GENOA CHARTER TOWNSHIP BOARD
Regular Meeting
August 17, 2026
6:30 p.m.

Attention:	Amy Ruthig, Planning Director
Subject:	MHOG Administration Building – Site Plan Review #2
Location:	900 Chilson Road – west side of Chilson Road, north of I-96
Zoning:	PRF Public and Recreational Facilities District

**Re: MHOG Administrative Building
Site Plan Review No. 2**

RE: MHOG Utility Building
900 Chilson Rd.
Site Plan Review

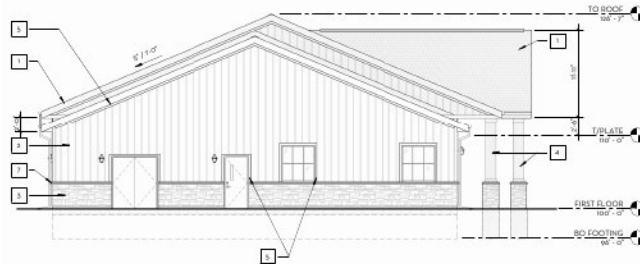
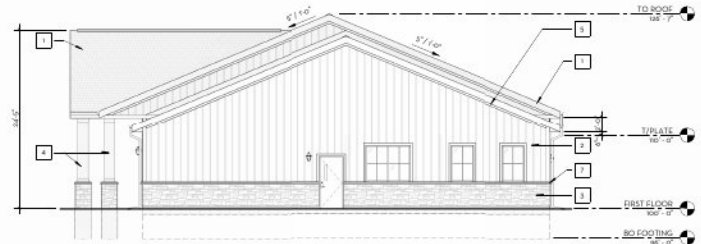
Based on the calculations provided, the building exceeds the limit for siding for new buildings in the PRF. However, Section 12.01.04 does allow the Commission to approve modifications when it is in keeping with the intent and purpose of the Ordinance. The project architect has submitted a letter stating their rationale for alternative building materials (letter dated 7/17/26 from Fika Architects).

1. We request the applicant provide building material calculations demonstrating compliance with the material standards of Section 12.01. **Acknowledged. The required calculations have been provided on Sheet A2-01.**

2. Building materials and color scheme are subject to review/approval by the Planning Commission. **Acknowledged. We have provided a material color scheme on sheet A2-01.**
